Whipple Consulting Engineers, Inc.

**Re: Legacy Ridge West – A Residential Subdivision (2014.PL0003)
Reasonable Use Exception – Response to Comments**

This letter is our response to your comments from the original submittal for the Reasonable Use Exception. The email of the comments is attached and is dated March 24, 2025. The preparation time for this submittal was two-fold, preparing documentation to answer the RUE comments, but also to catch the plat up by preparing a Minor Map Modification along with open space calculations as well as client input.

Figure 1, Minor Map Modification Exhibit

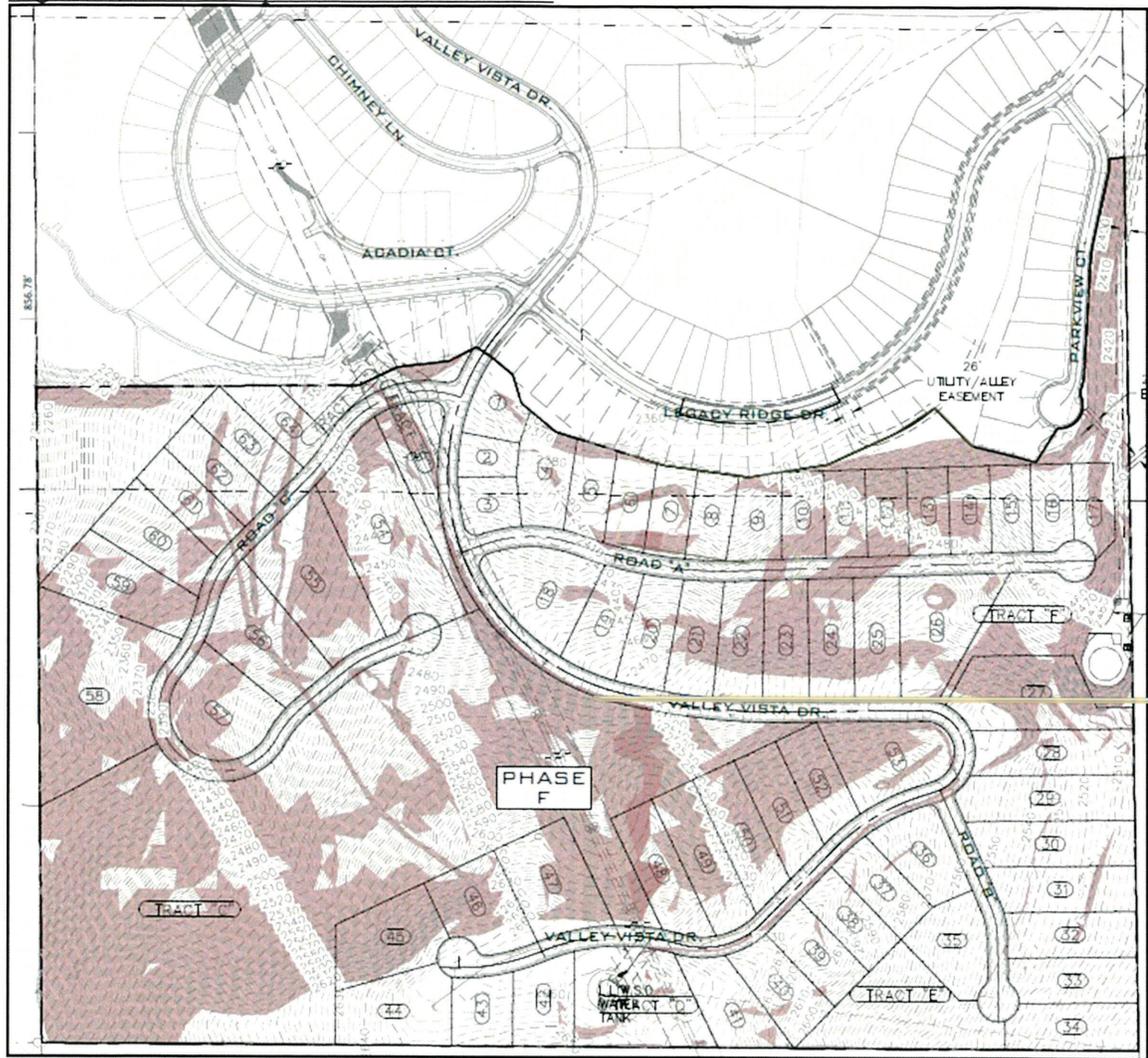
- The reasonable use request should encompass all new lots and new roadways proposed, not just those west of Valley Vista. Notably, the newly proposed lots east of Valley Vista were either proposed as common open space or "private common area", not to be developed (see graphic, below).

Attached to this submittal is the updated lot layout for a Minor Map Amendment along with area calculations. By making the proposed changes we were able to limit the impact area west of the main road. The previous concerns were presented with the changes shown, unfortunately, the Minor Map Modification, was not submitted at that time. An exhibit showing the affected areas from the Taylor Engineering Preliminary Plat and the Minor Map Modification is shown in Figure 2.

Figure 2, Slope and Erodible Soil exhibit.

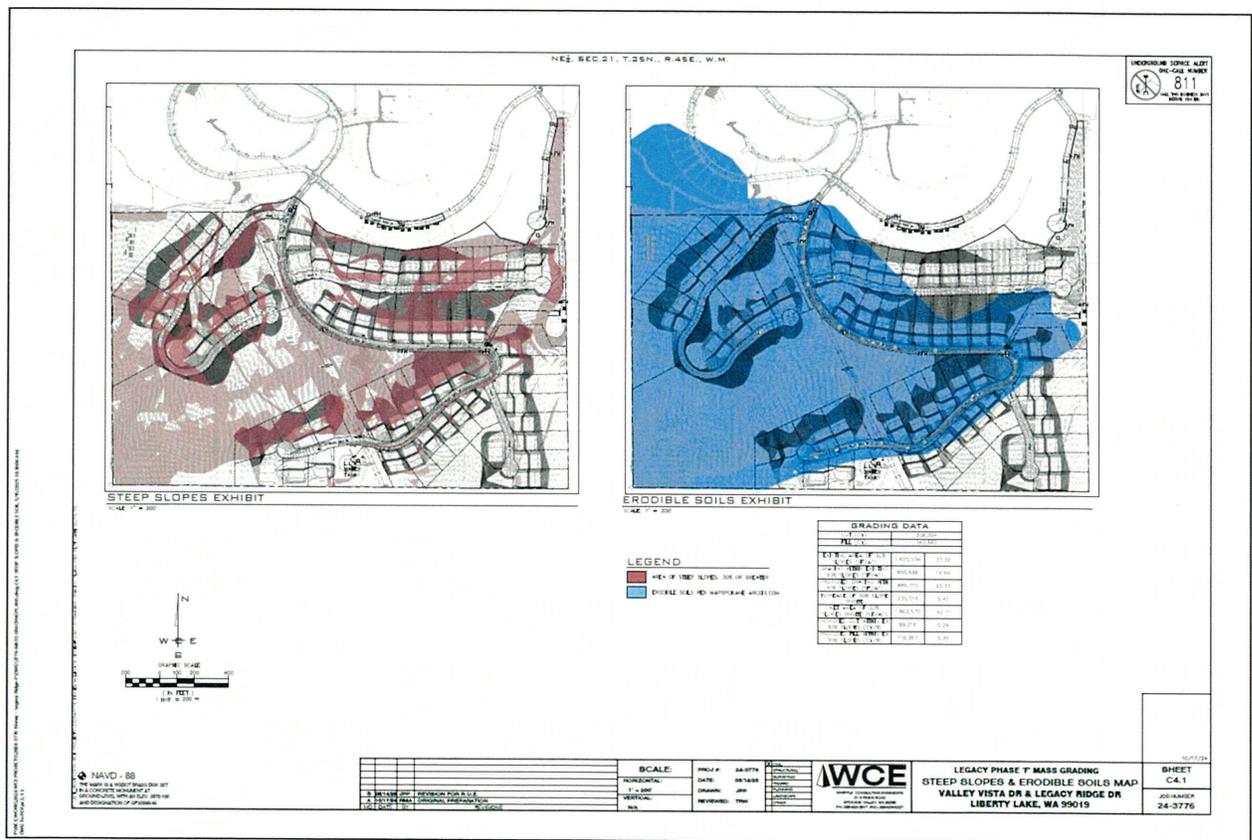
- Please provide an updated Grading Plan Sheet (see attached), with an overlay of the existing 30% slopes indicated in red, and the identified erodible soils in blue.

This has been prepared and is included as an attachments, snippets are shown here for reference.

Figure 5 – Areas of Impact (see appendix for a larger version)

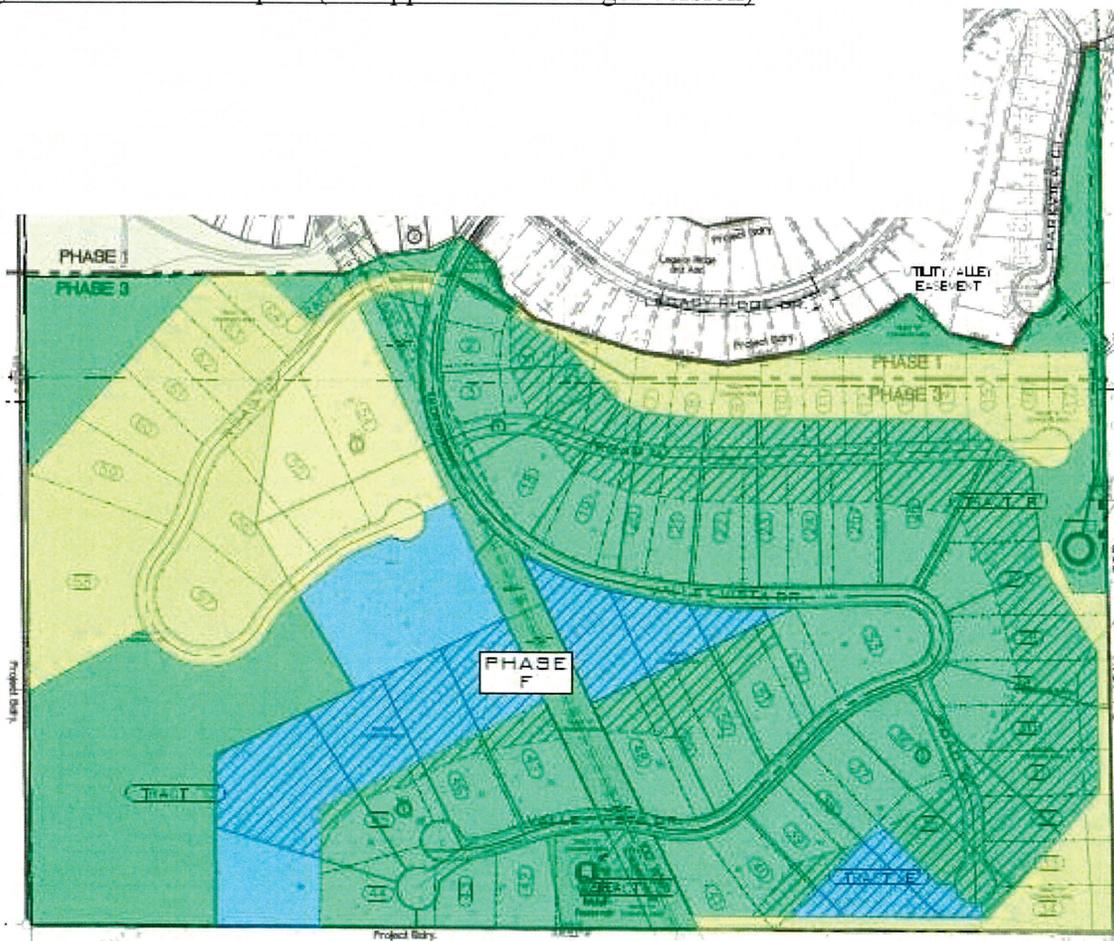
- Because it is unclear how much impact the excavation/fill will have on areas of 30% and identified erodible soils, how can it be determined that this alteration to the geo-hazardous areas is the minimum necessary to allow reasonable use?

The figure below demonstrates how little impact is required when you compare the blue to light green. The dark green represents no change from what was proposed as a part of the original preliminary plat.

Our response to the inquiry and in relation to the values provided, my personal and professional experience having worked on developing over 15,000 single family residential lots in subdivisions over the last 30 years tells me what is necessary and reasonable for development. Because of the Urban Growth Boundary, there are very few if any project or developable lands that are available that do not have 30-percent slopes, erodible soils, wetland, streams, or other critical areas. And that experience has brought us to the conclusion that without the RUE, this land most likely will not be developed. As shown in Figure 5, hopefully, you will come to the same conclusion that we as a design team came to, which is while there is impact it is reasonable when considering the option of not developing the site.

**LEGACY PHASE F MASS GRADING
 STEEP SLOPES & ERODIBLE SOILS MAP
 VALLEY VISTA DR & LEGACY RIDGE DR
 LIBERTY LAKE, WA 99019**

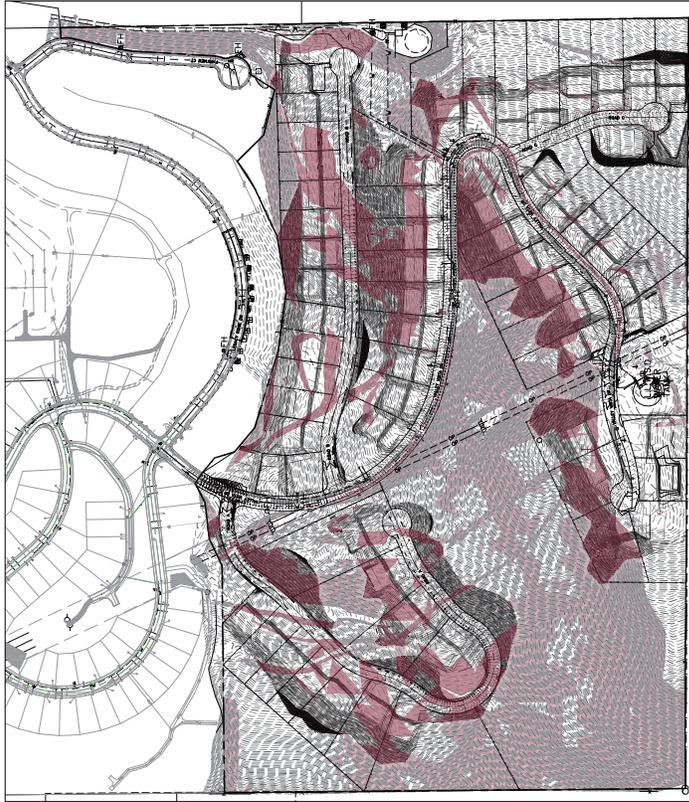
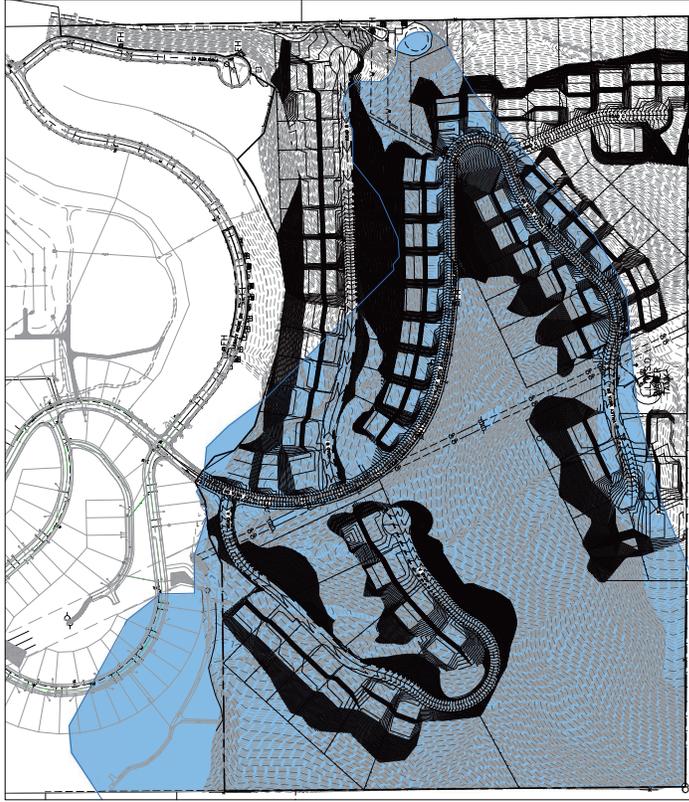
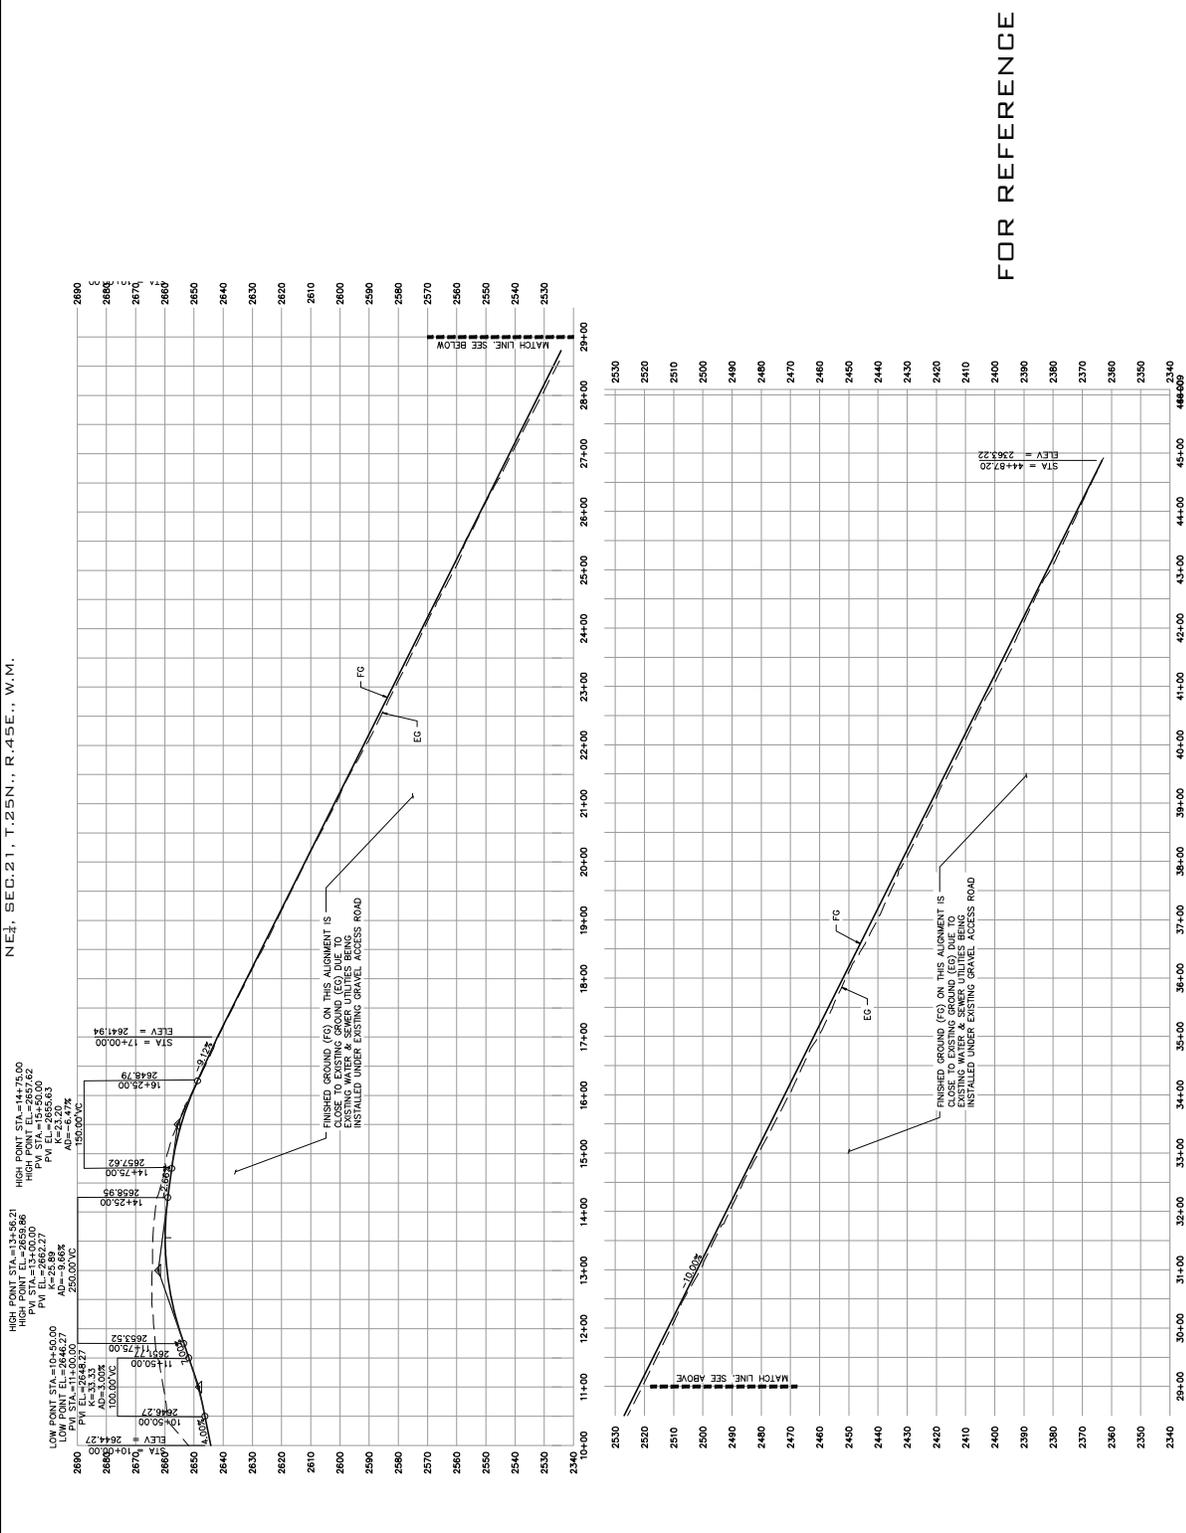
- Please provide data on the % of the 392,000 CY of proposed cut that will be removed from existing areas of 30% slope.
- Please provide data on the % of the 360,000 CY of fill that will be placed in areas of existing 30% slope.

GRADING DATA	
CUT (CY)	305,304
FILL (CY)	342,862
EXISTING AREA OF 30% SLOPES (SF/AC)	1,625,556
PROPOSED GRADING WITH 30% SLOPES (SF/AC)	606,686
INCREASE OF 30% SLOPE	885,710
ON-SITE	235,014
OFF-SITE	1,860,570
PROPOSED CUT WITHIN EX. 30% SLOPES (CY)	89,016
PROPOSED FILL WITHIN EX. 30% SLOPES (CY)	118,363
NET ON-SITE	0.35
